Item No. 10.2.1
Regional Centre Community Council
February 24, 2021

SUBJECT: Case 23161: Appeal of Site Plan Approval – 6459 Bayers Rd., Halifax

6459 Bayers Rd.,
Halifax - New 8 Unit
Building

① Elevation - Front (Small Scale)
1/16" = 1'-0"

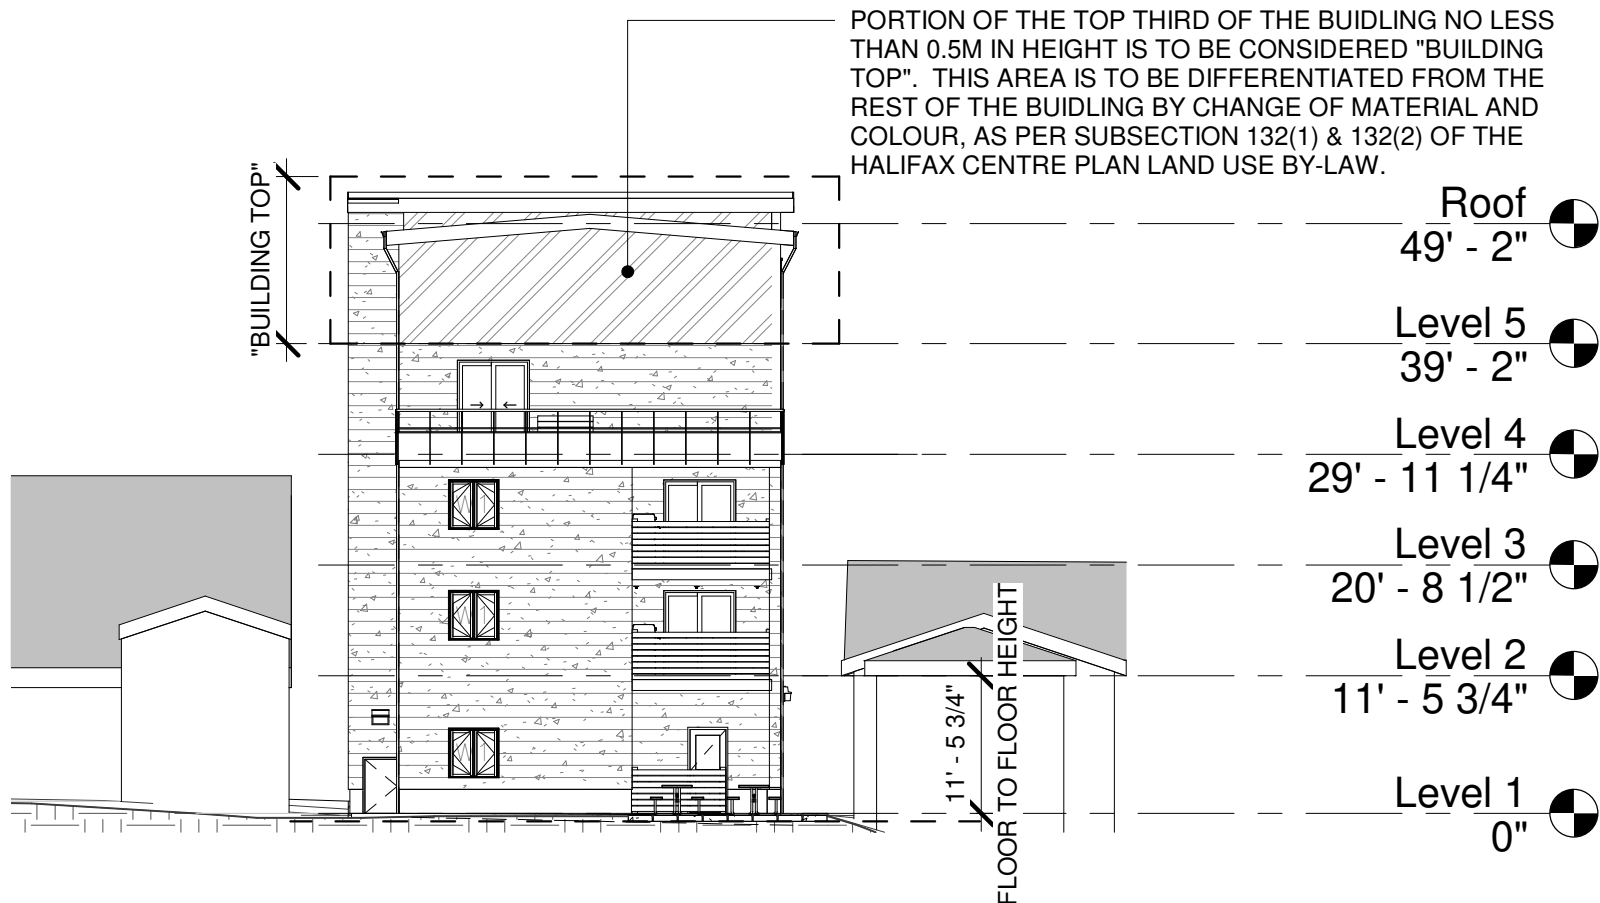
<p><u>Part VI, Chapter 3, Section 128: Ground Floor Transparency – Grade Related Uses</u></p> <p>We are seeking clarification on the calculation used to determine the amount of glazing required. Without a floor plan, we are unable to determine how much of the streetwall is dedicated to the grade-related unit. Assuming the entire width of the ground floor façade relates to the grade-related unit (9.7 m width by 3.0 m height), the 50 square foot of glazing provided by the one window and door would not meet the minimum requirement of 25%.</p>	<p>A portion of the building along the streetwall is used for common building utility or storage purposes. Based on the area of the remaining portion of the streetwall, 4.4 square metres of glazing is required, and the proposal includes 4.6 square metres of glazing, which meets the requirement.</p>
<p><u>Part VI, Chapter 6, Section 154: General Lighting</u></p> <p>It is unclear in the plans and drawings provided if the doorway and stairs shown on the front elevation is a common access or not. More broadly, we have concerns about the type of lighting being proposed as this has the potential to directly impact neighbouring properties. For example, the main shared entrance is located on the side of the building and immediately adjacent to the existing residence and lighting for the private open-space in the rear yard could impact all abutting properties.</p>	<p>The building entrances on the front elevation are not common building entrances, and are not required to be illuminated under section 154, although there is nothing prohibiting this from being illuminated. Regardless of the function of the entrance, section 47 of the land use bylaw prohibits light from being directed towards streets or adjacent properties, and requires the use of full cut-off lighting fixtures. Specific details of lighting fixtures have not been provided yet, as this is not a design requirement, but it will be confirmed as part of the permit review. The lighting requirements are outside the scope of the consideration of the appeal.</p>

Appeal: We are seeking clarification on the calculation used to determine the amount of glazing required. Without a floor plan, we are unable to determine how much of the streetwall is dedicated to the grade-related unit. Assuming the entire width of the ground floor façade relates to the grade-related unit (9.7 m width by 3.0 m height), the 50 square foot of glazing provided by the one window and door would not meet the minimum requirement of 25%.

① Elevation - Side (1) (Small Scale)
1/16" = 1'-0"

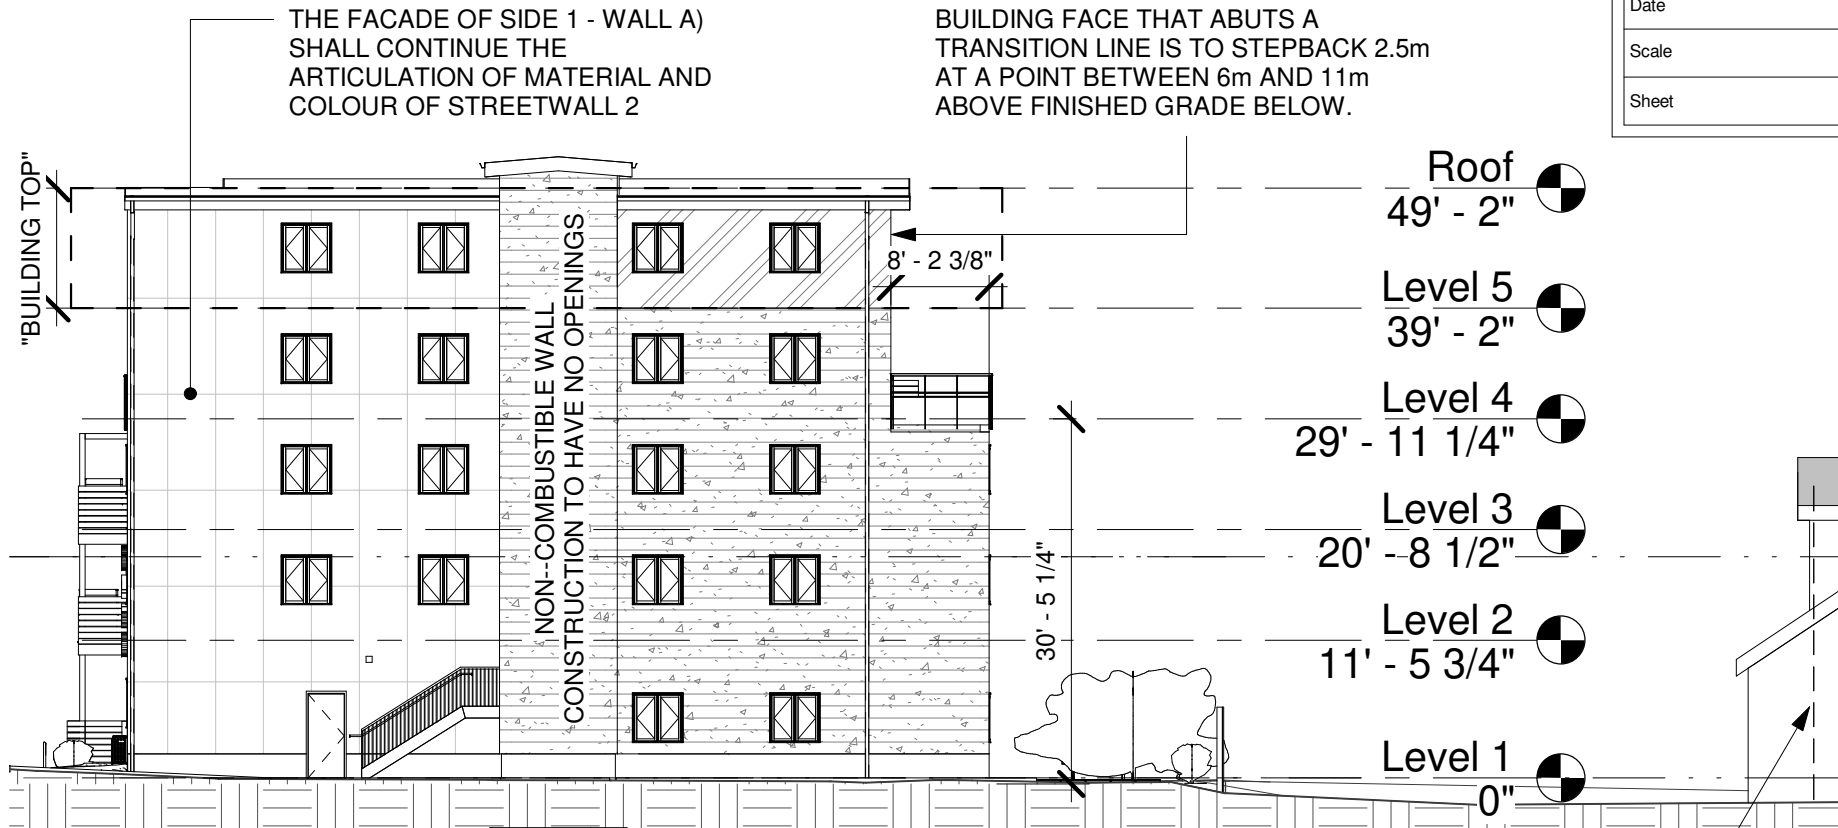
<p><u>Part VI, Chapter 3, Section 122: Articulation of Non-Streetwalls Fronting an At-Grade Private Open Space</u></p> <p>The side exterior walls of the proposed building abut neighbouring private open spaces which abut a public right-of-way (Bayers Road). The proposed siding treatment would not meet the requirements of Section 121 as it appears to exceed the maximum 8.0 m in width without a differentiation in materials, colours or projections and recesses.</p>	<p>The requirements of section 122 apply to building walls along an at-grade private open space on the same lot, not side yards on adjacent lots. As there is no at-grade private open space along the sides of the building, the requirements of section 122 do not apply to these walls.</p>

Appeal: The side exterior walls of the proposed building abut neighbouring private open spaces which abut a public right-of-way (Bayers Road). The proposed siding treatment would not meet the requirements of Section 121 as it appears to exceed the maximum 8.0 m in width without a differentiation in materials, colours or projections and recesses.

Attachment B - Site Plan

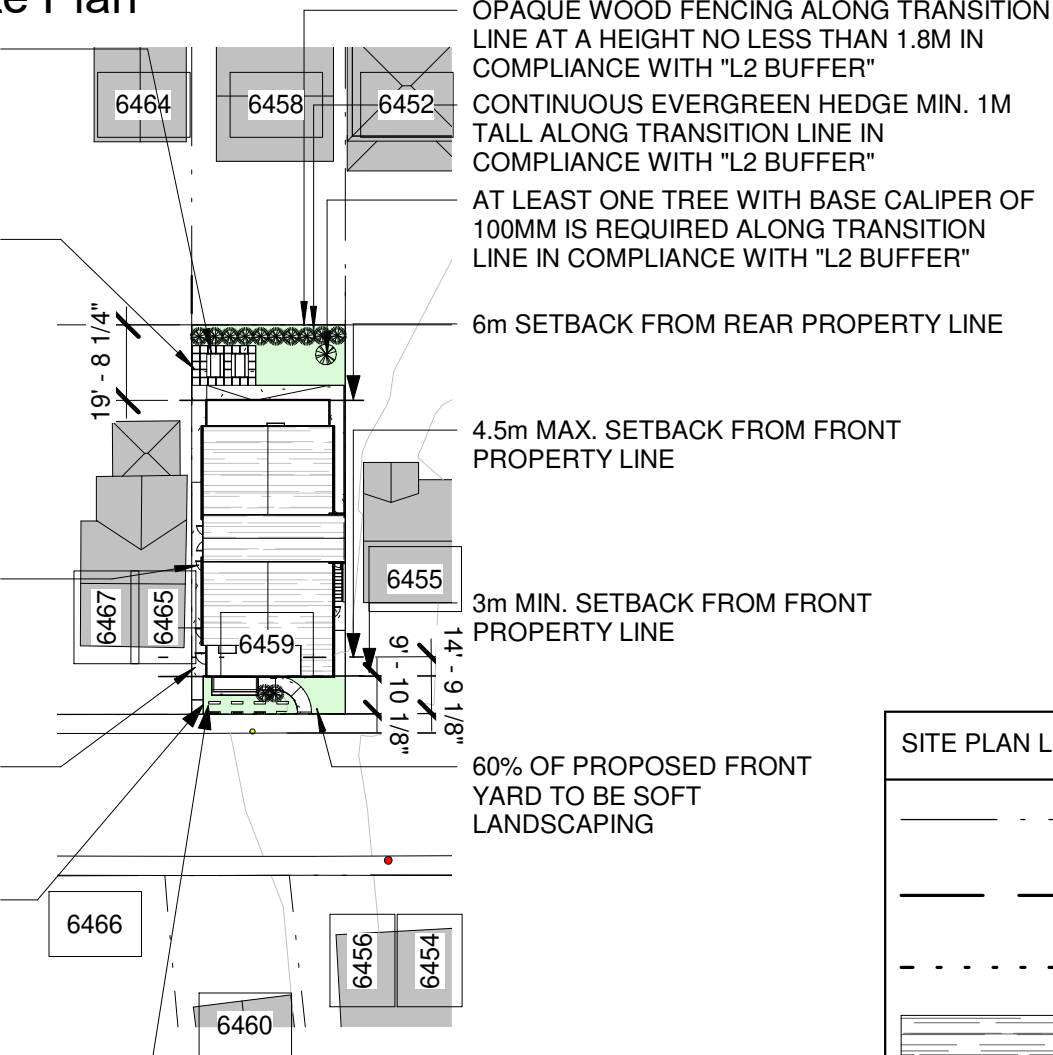
<p><u>Part VI, Chapter 2, Section 114: At-Grade Private Open Spaces Abutting a Public Sidewalk</u></p> <p>No dimensions have been given for the walkway connecting the at-grade private open space for the unit fronting Bayers Road and the Bayers Road sidewalk. On the site plan it appears to be less than 2.0 m in width based on the dimensions provided for the 3.0 m building setback.</p> <p>The public realm and relationship of the building to the street could be improved by having a deeper front patio for the at-grade unit fronting Bayers Rd. This would better relate to the street and improve the usability of this space particularly for persons with mobility challenges who may otherwise benefit from an at-grade dwelling.</p>	<p>The open space in front of the grade-related unit is a patio, which is required under section 90(4)(a) of the land use bylaw and must be a minimum depth of 1.5 metres. The patio is considered a required part of the building, and as such, does not constitute an at-grade private open space, and does not have to meet the 2 metre pedestrian access requirement.</p> <p>Accessibility considerations are contained within the building code, not the land use bylaw. Before a construction permit can be issued, the Building Official will have to be satisfied that the units meet any applicable accessibility requirements.</p>

<p><u>Part VI, Chapter 2, Section 116: Weather Protection for At-Grade Private Open Spaces</u></p> <p>A new deciduous tree with a base caliper of at least 100 mm is shown on the site plan however, it is located at the far side of the rear yard and not adjacent to the seating area offering little weather protection for those using the seating area. The site plan refers to a separate zoning requirement for the tree which relates to requiring landscape buffers along the transition line rather than weather protection.</p>	<p>Weather protection for the at-grade private open space is provided by the referenced deciduous tree, as well as the balconies which cantilever over the rear entrance to the building, which are both listed as options in section 116. While the new deciduous tree is required as part of the landscaping buffer, there is nothing in the bylaw which precludes the use of this tree to satisfy both the requirements for weather protection and landscaped buffering.</p>

Appeal: No dimensions have been given for the walkway connecting the at-grade private open space for the unit fronting Bayers Road and the Bayers Road sidewalk. On the site plan it appears to be less than 2.0 m in width based on the dimensions provided for the 3.0 m building setback.

Appeal: a new deciduous tree with a base caliper of at least 100 mm is shown on the site plan however, it is located at the far side of the rear yard and not adjacent to the seating area offering little weather protection for those using the seating area. The site plan refers to a separate zoning requirement for the tree which relates to requiring landscape buffers along the transition line rather than weather protection.
